Packet Guide
City of Charlottesville
Board of Architectural Review
Regular Meeting
April 15, 2025 5:30 p.m.
Hybrid Meeting (In-person at Council Chamber and virtual via Zoom)

**BAR MINUTES
CITY OF CHARLOTTESVILLE
BOARD OF ARCHITECTURAL REVIEW**

**City of Charlottesville
Board of Architectural Review
Staff Report
April 15, 2025**

HST25-0072

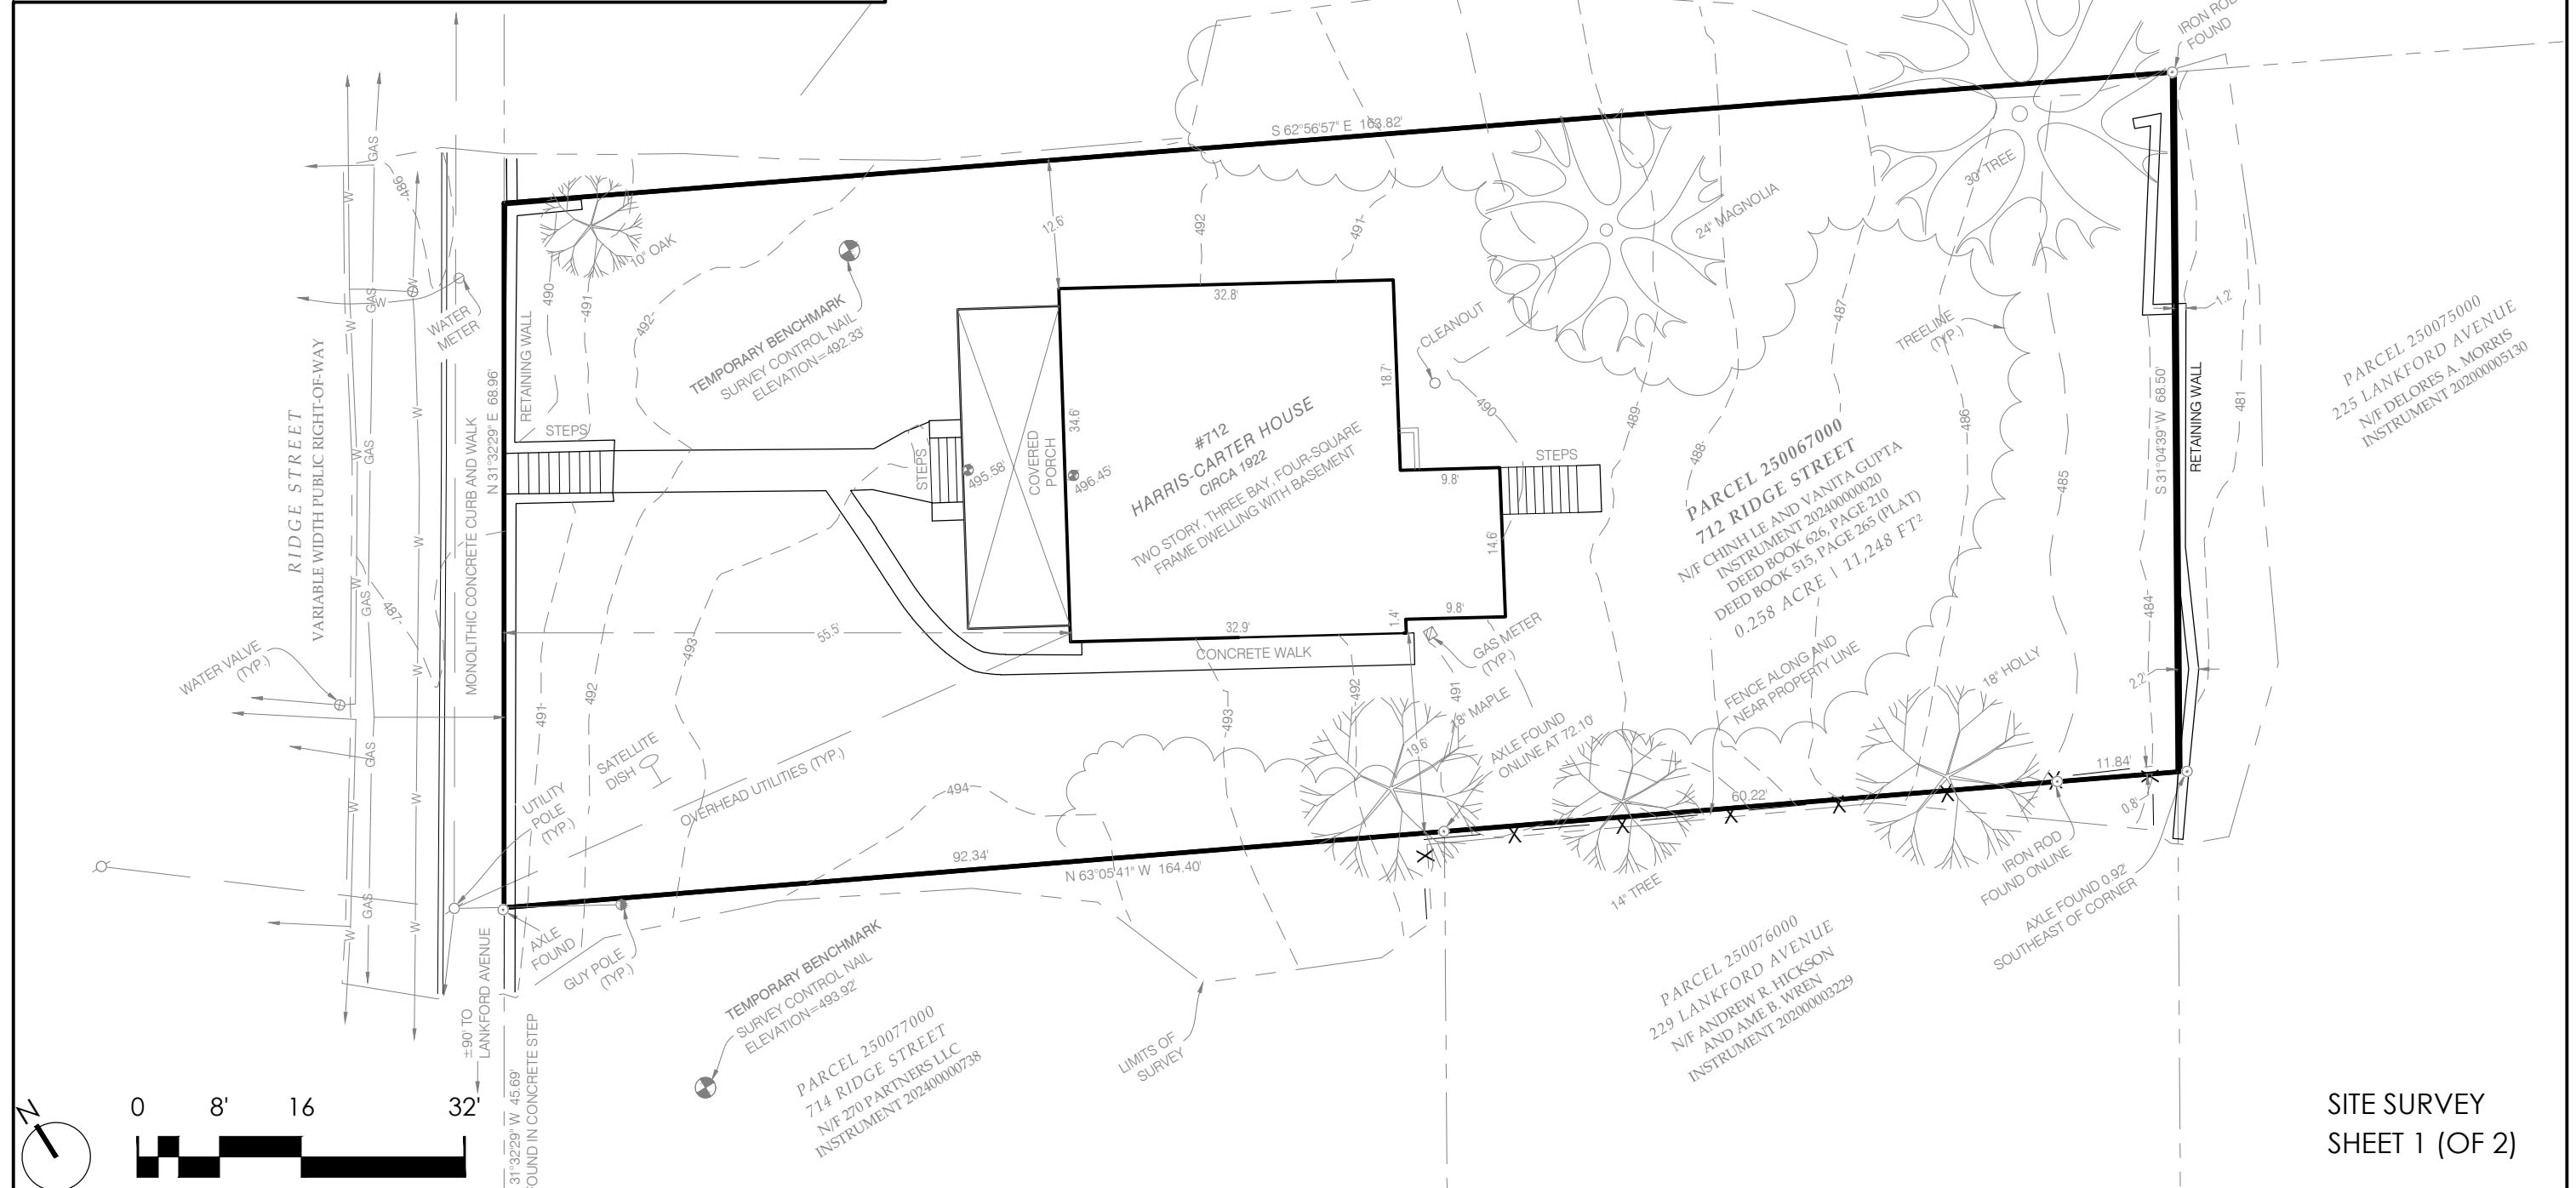
Mr. Zehmer – We have a marked-up photograph. There was a reference to, in terms of a paving surface, what we typically go for with driveways and walkways in the guidelines. Mr. Gastinger's point is well taken. There was no formal site plan submitted, which would show us the driveway potential parking area. It may be acceptable if it was in the rear and details of the retaining wall that would need to be installed.

Mr. Whitney – Are there site trees that would be removed for the driveway?

Mr. Zehmer – I would like to see a site plan with details regarding the retaining wall.

Mr. Werner – There is a large dead tree. I did tell the applicant that the tree looks dangerous, and it should be removed ASAP. The last time we had a big front yard driveway discussion was that house on Park Street. By code, you are allowed to use 25 percent of the front yard for parking. You can't turn it into a parking lot. You can constrain things with a no 3-point turn place. If it is paved, someone can put a car there. With the extent that that would maybe go into the front yard, you can look at that. A drawing of some type that you would like to see would be helpful to express to me and the applicant what it is that we would like to see. He can then prepare that. If it is just unacceptable to do it, that would be helpful for him to know before he hired a contractor to develop some drawings.

Date: April 8, 2025

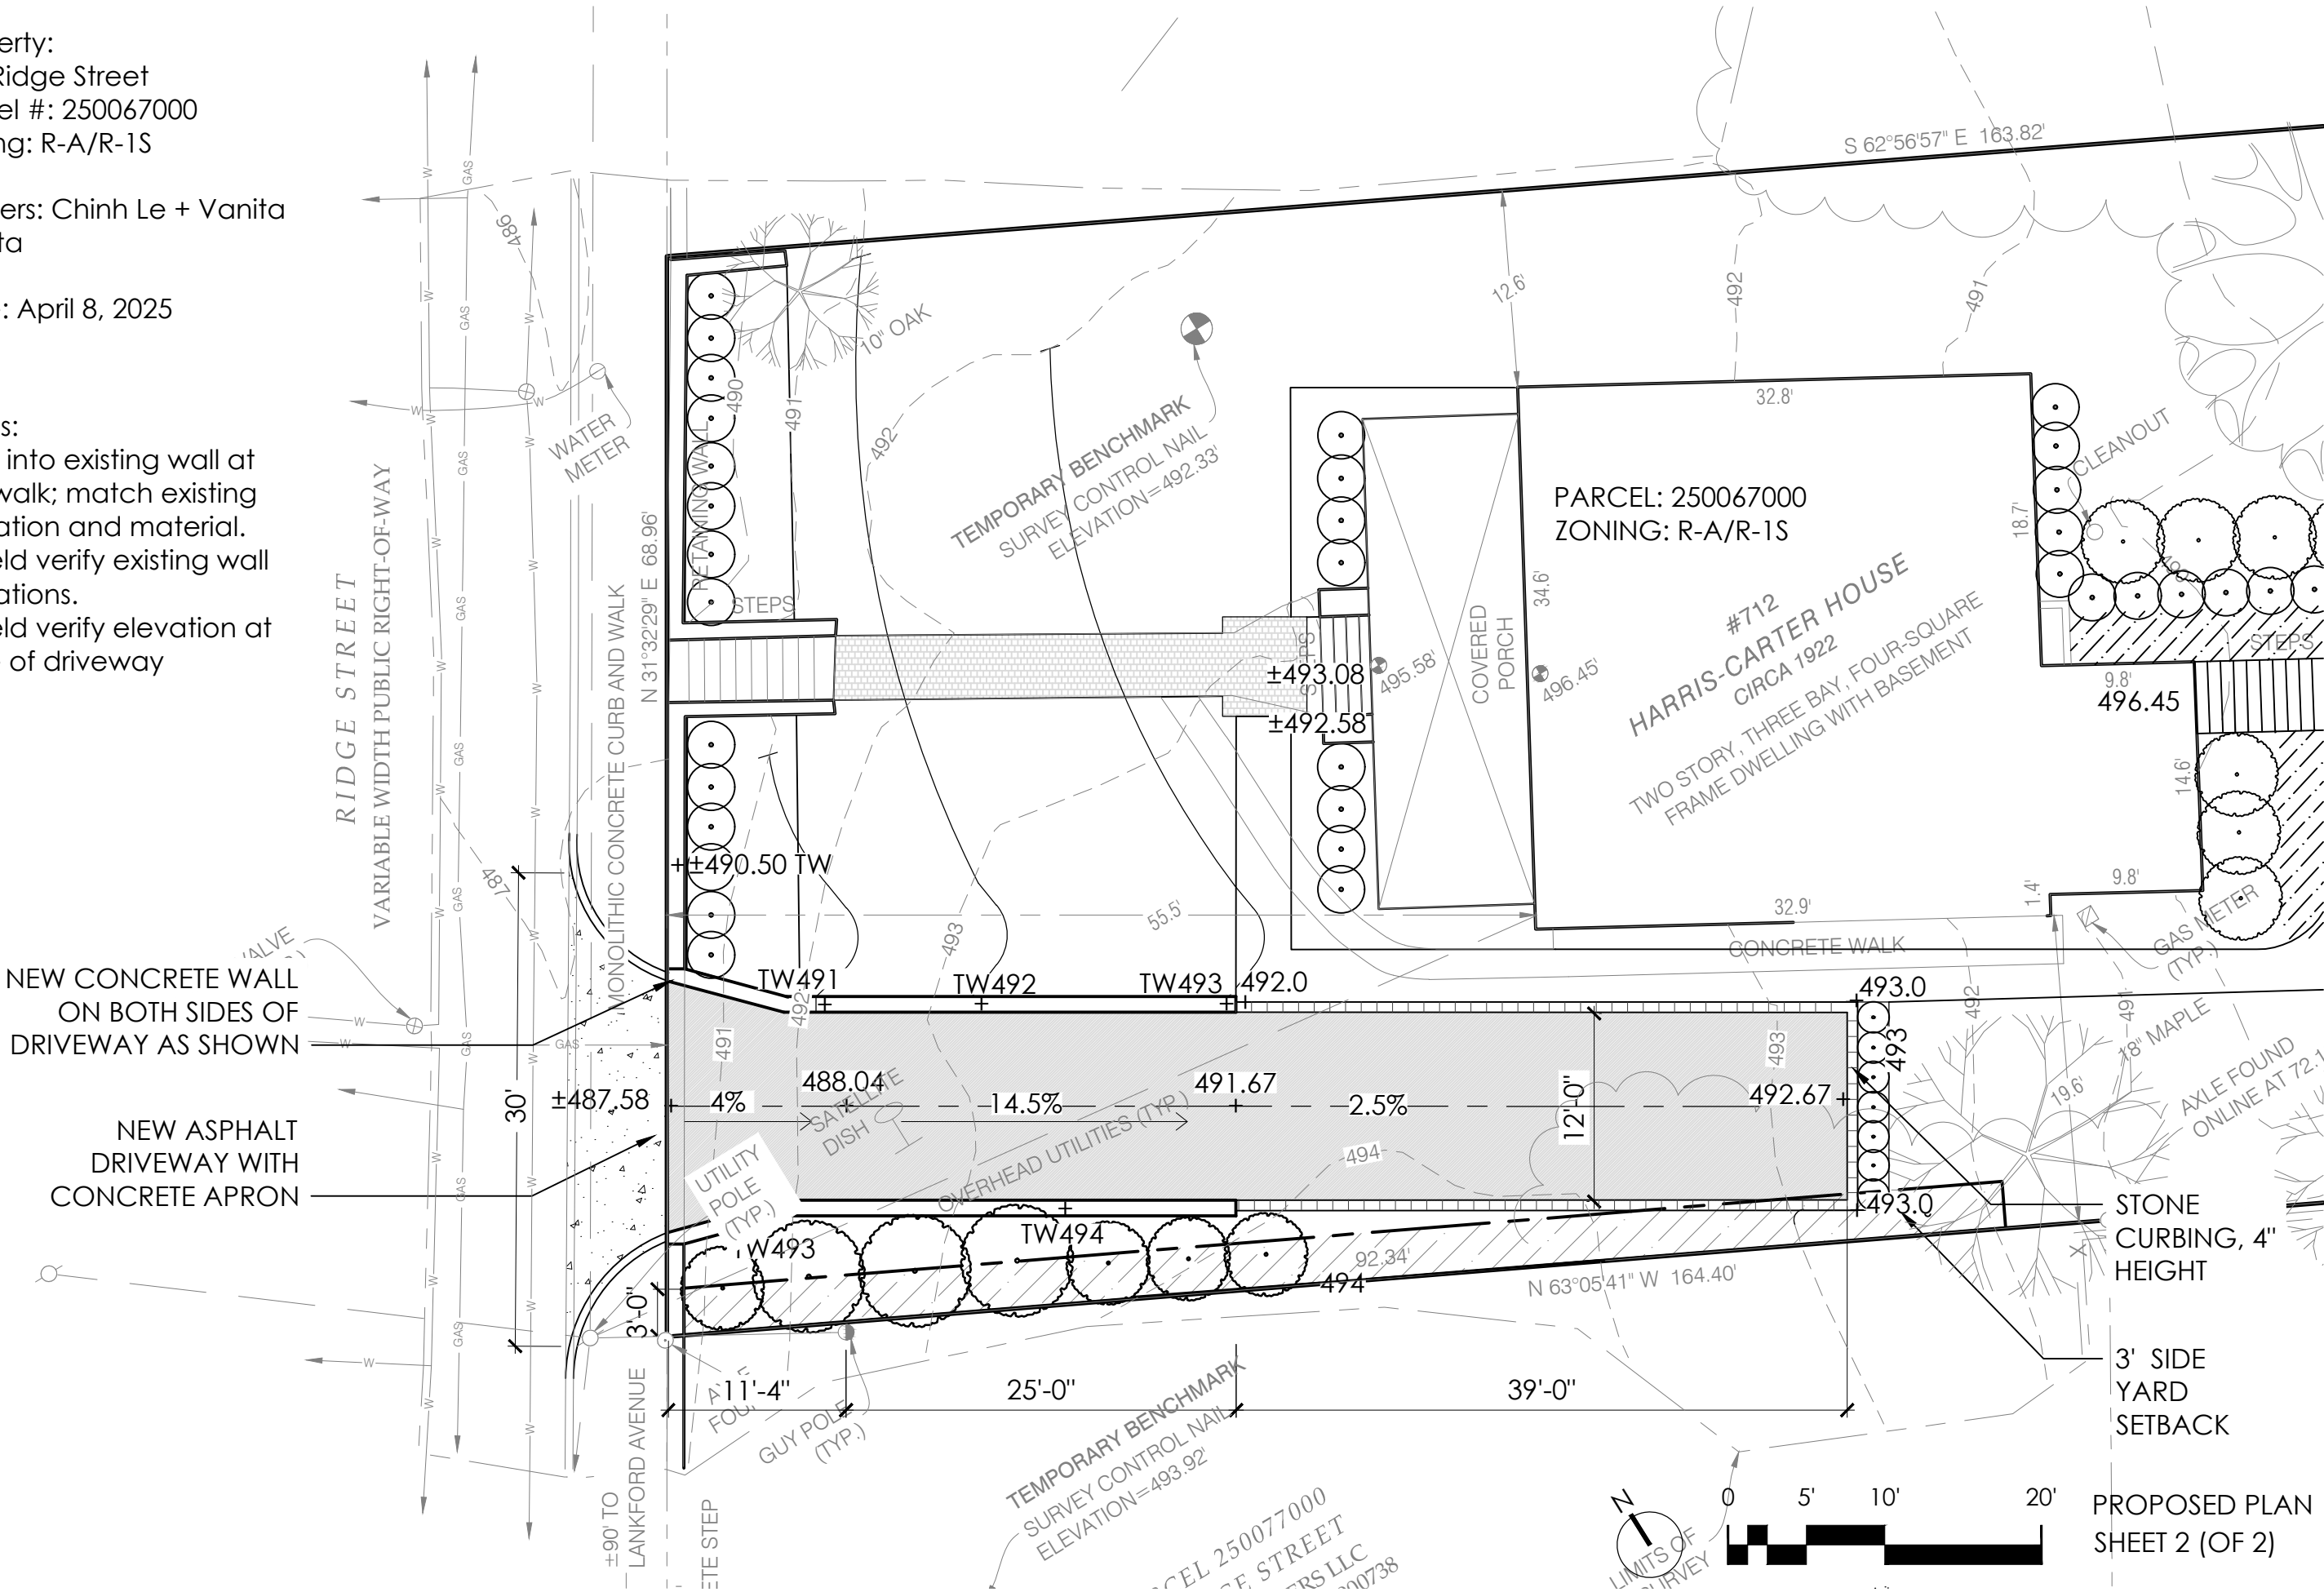
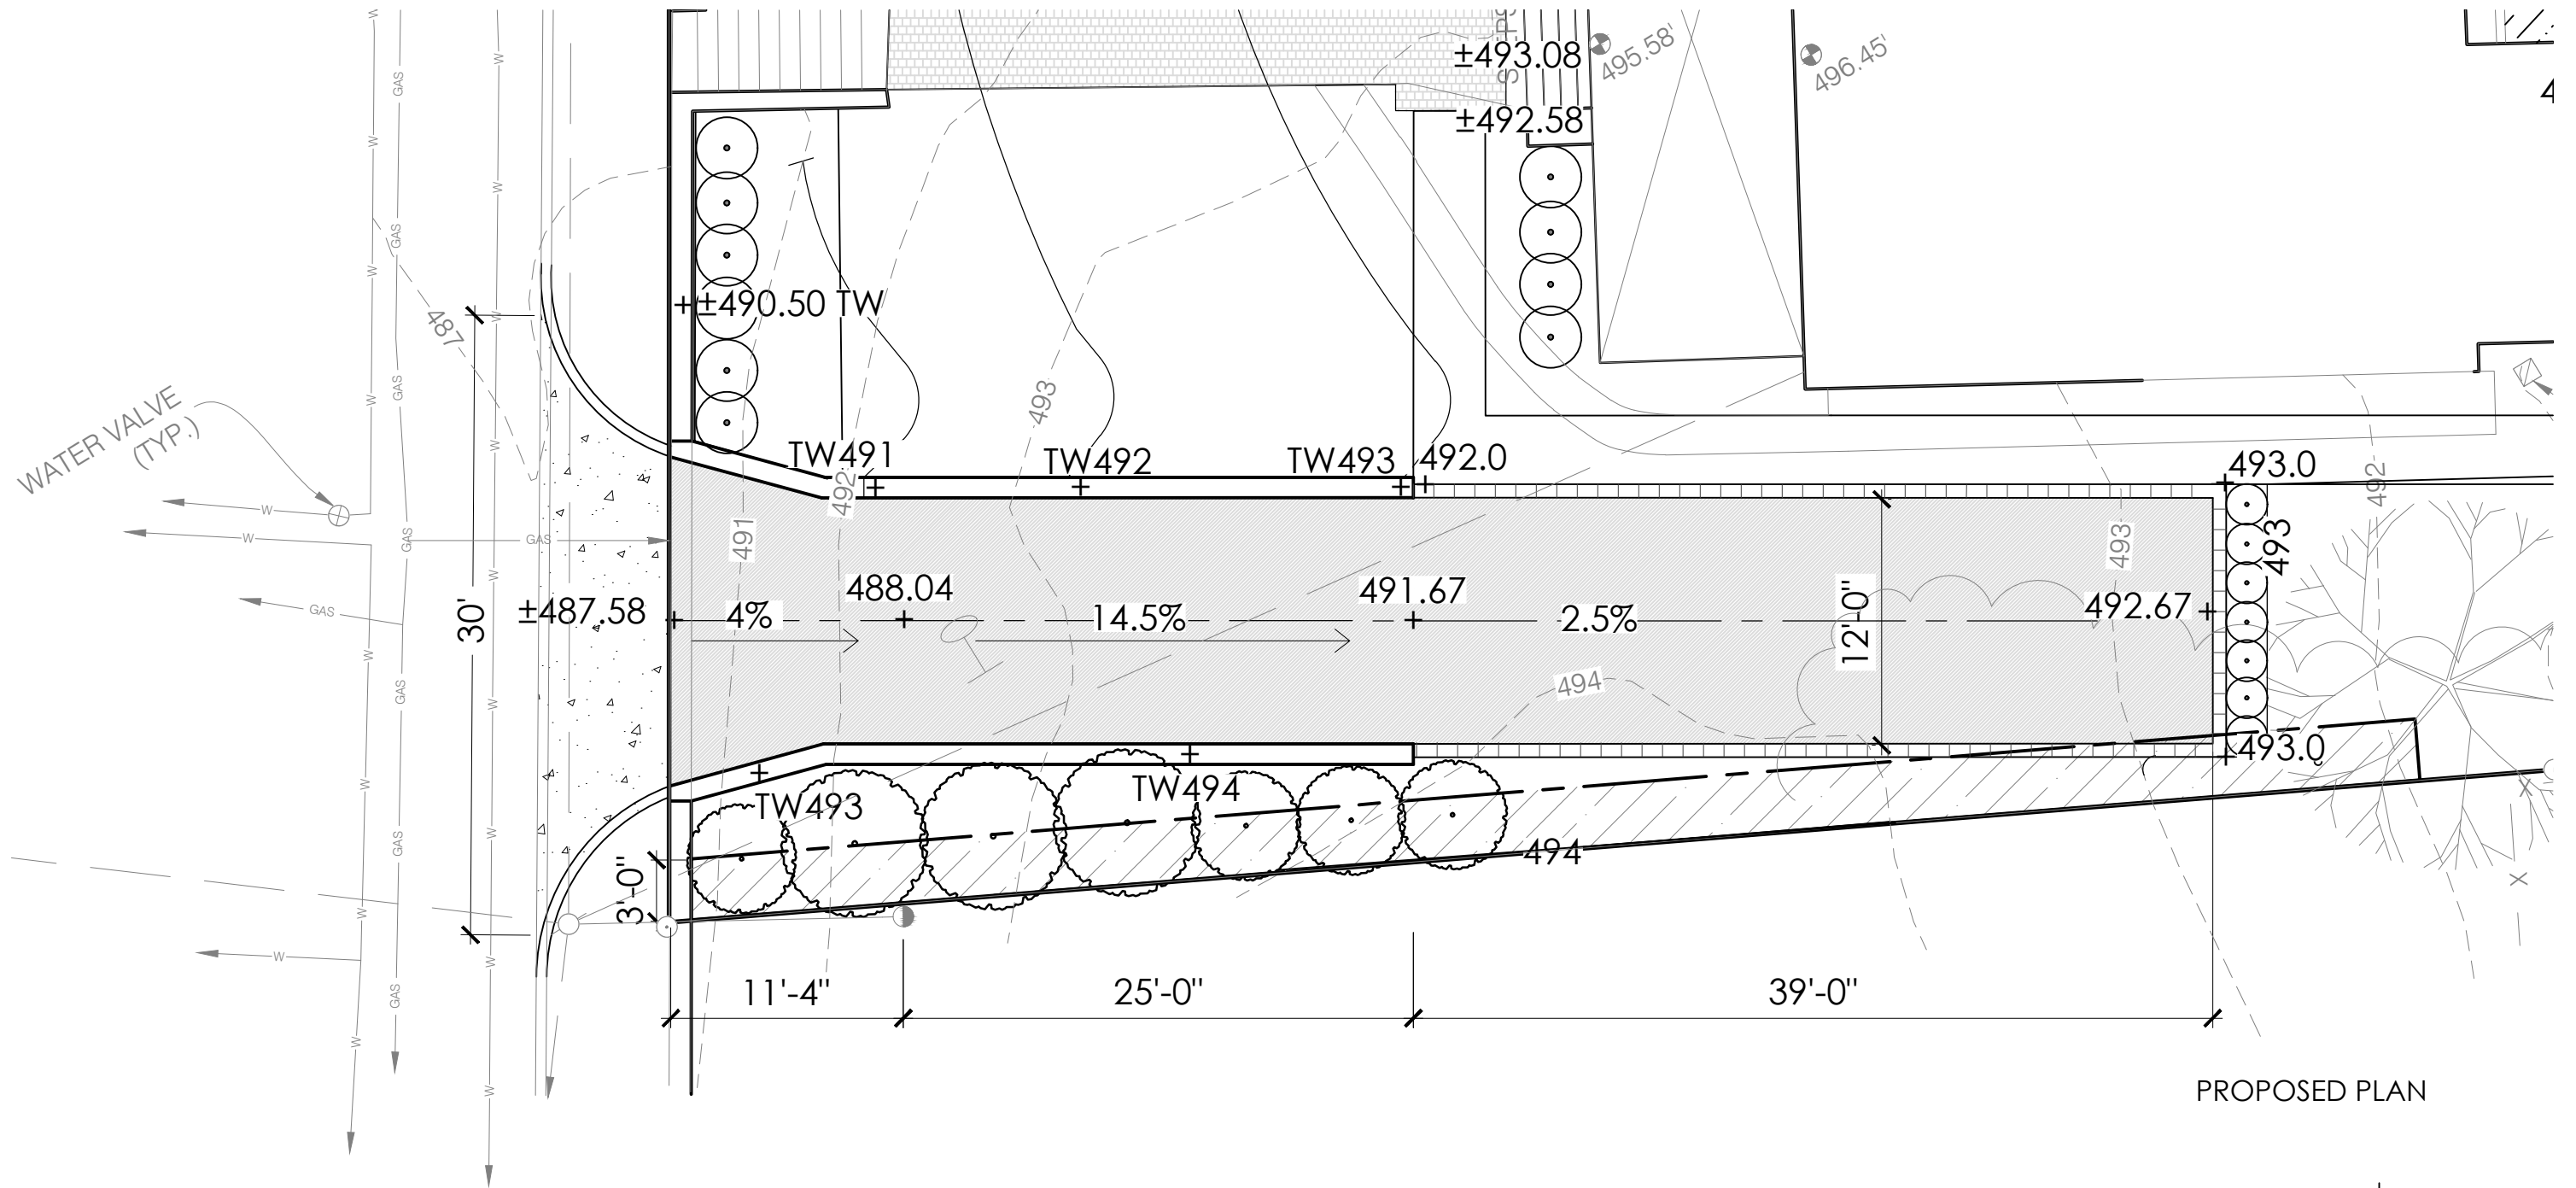
This project would entail puncturing the existing concrete retaining wall running along the Ridge Street property boundary to provide off-road access to the residence. New concrete

retaining walls will wrap into the site along both sides of the new asphalt drive. The new concrete retaining walls would match the height, material, and character of the existing walls at the street, and taper or step down to meet grade. A cobble curb would wrap the edges of the asphalt drive and provide a clean edge and transition between materials. Other proposed site improvements include re-grading the front portion of the property to ease the overall slope and to meet newly proposed top of wall grades at the driveway, as shown in plan. The existing front concrete walkway may also be updated and replaced with natural stone material including a new stone landing at the front porch. Secondary pathways on the site will be stone dust or pea gravel material with steel edging.
